HUTT CITY PROPOSED DISTRICT PLAN HEARING STREAM 7 – SUBDIVISION

SUPPLEMENTARY NOTE OF DIETER ENGEL – PDP/475.4 - Hydraulic neutrality – Continued

Submitter: Dieter Engel – PDP/475 , 10A Bloomfield Terrace, Lower Hutt

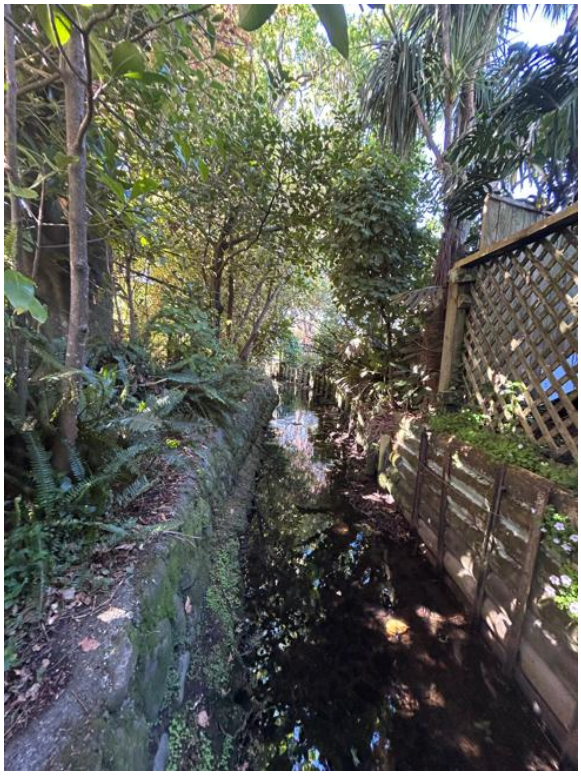
This is Hutt City's published flood mapping at my property. The map shows floodwater extending across my house and much of the site, including very substantial modelled depths.

The physical site does not appear flat. The Opahu Stream runs along the low eastern side of the property. My back lawn is above the stream and the land rises past the house toward the vehicle parking area on the western side. I estimate that the parking area is approximately 1.5m to 2m metres above the stream-bank level, although I do not have a topographical survey establishing the exact difference.

How does the modelled 1% AEP flood extent, which appears to inundate the whole house and extend substantially further upslope, reconcile with the actual flood history observed at this property over many decades?
